City of Apache Junction

PLANNING AND ZONING COMMISSION PUBLIC HEARING STAFF REPORT

CASE NUMBER: PA-1-17

REQUEST: An application requesting approval of a Private Access Way ("PAW"), as part of proposed land split case LSM-2-17.

APACHE JUNCTION LAND SPLIT MAP

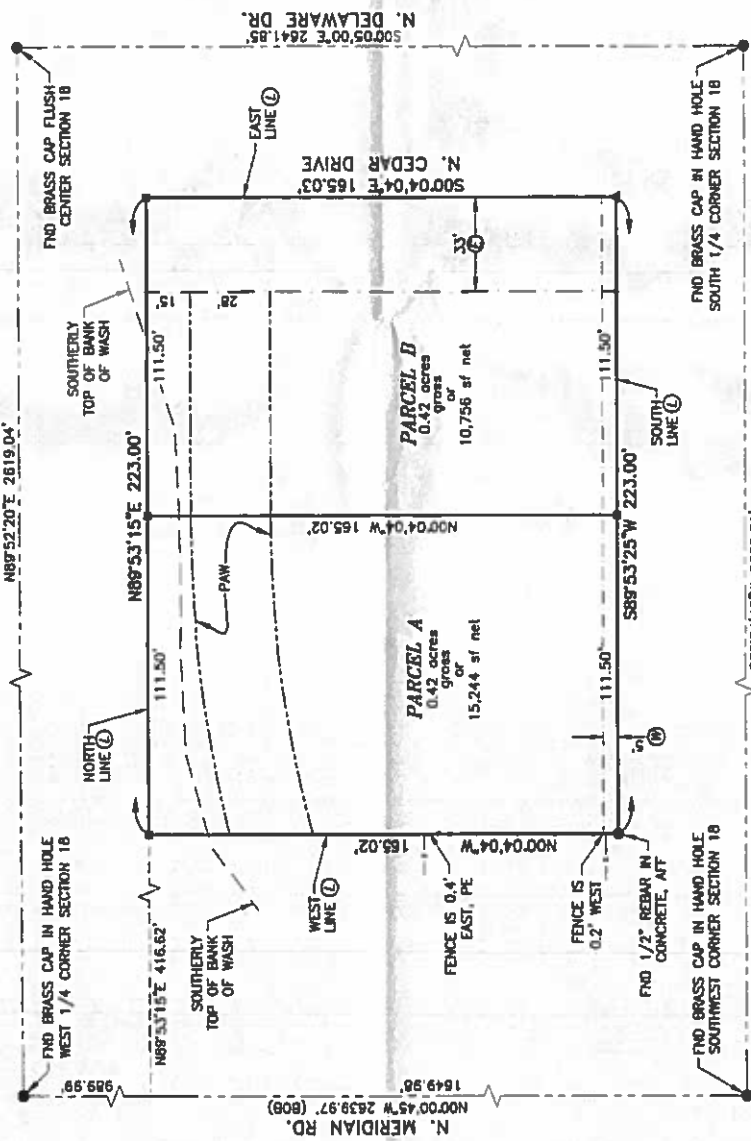
For the purpose of being able to split his property in accordance with proposed land split map LSM-2-17, Mr. Barker seeks the Commission's recommendation and ultimately, Council approval of a PAW across the north side of his property. Because of an existing wash which encumbers the north side of the property, the PAW is proposed to be located about 15 feet south of the north property line as shown on the land split map. Pursuant to the city's regulations for private access ways (Zoning Ordinance, Section 1-7-6 attached), the PAW will be 28-feet wide, is proposed to be improved with chip seal or crushed asphalt, will serve Mr. Barker's proposed new west lot, and it will continue to serve Mr. Berry's property to the west.

The property is zoned RS-10M, which requires net lot sizes of 10,000 square feet. The proposed land split shows that the west lot will be 15,244 net square feet; and the east lot will be 10,756 net square feet *after* the dedication of the 33-foot-wide Cedar Drive easement. The proposed split complies with zoning.

- A) Private streets shall be a minimum of 28 feet in unobstructed width of paved surface (back of curb to back of curb, if curbs are installed) with a 20-foot by 20-foot cutoff at the intersections or a minimum turning radius of 20 feet. Narrower private streets may be permitted subject to City Council review and approval. *[Street improvements on N. Cedar Drive and in the general area are incomplete. Minimum paving improvements do exist, but there do not appear to be curbing or sidewalk improvements in the general area, not even along Meridian. Although PAW requests are very rare, the City Council has never required full street improvements as part of a PAW request. In the past, Council has looked at improvements in the surrounding area and required similar or lesser improvements for a PAW. In this case, the applicant has offered to chip seal or install crushed asphalt to the edge of the existing pavement on Cedar.]*

1. Paving shall be installed according to City Engineering Guidelines for public residential streets, or in accordance with subdivision regulations, if applicable. Curbs, gutters, sidewalks and streetlights may be required by the Council. Alternate paving surfaces may be permitted by the Development Services Engineer; *[Full street improvements for this PAW would seem out of place and over-burdensome for a 2-lot split in this area. It appears the Development Services Engineer has some discretion over what types of improvements to require. Chip sealing, to the edge of the existing paving improvements on Cedar would seem to be a reasonable requirement for this case. Also see City Engineer's comments in e-mail dated 3-3-17 and the city's stabilization options from Ord. 1316.]*

2. Other requirements may be imposed by the Council for vehicular and pedestrian safety, utilities and emergency vehicle access; *[Issues with pedestrian and vehicular safety does not appear to be a factor for this 2-lot split. Staff will recommend a condition that emergency vehicles will be allowed to access the PAW. Secondly, Mr. Barker stated that one of his main reasons for asking for a west lot/east lot configuration is because a water line within a 5-foot-wide easement along the south side of his property already exists and also serves the lots to the west. Forcing him to extend a water main extension to a potential north lot would be cost prohibitive and would not serve any additional lots.]*

I move that the Planning and Commission recommend to the City Council the (APPROVAL/DENIAL) of case PA-1-17, a request for a Private Access Way by Wayne Barker, to serve existing and proposed properties pursuant to proposed land split case LSM-2-17, subject to the following conditions of approval:

- 1) The property owner shall coordinate with the city's Public Works' City Engineer's office to prepare and execute a right-of-way dedication document for his half of the N. Cedar Drive federally patented easement.

- 2) The property owner shall finalize land split map LSM-2-17 and shall record deeds for the new properties approved by LSM-2-17.
- 3) The property owner in case PA-1-17 shall improve the PAW with a chip seal treatment to the edge of the N. Cedar Drive improvements, to be approved and inspected by the city's Development Services and Public Works Engineers, including the securing of any necessary permits to do work in the city's right-of-way.
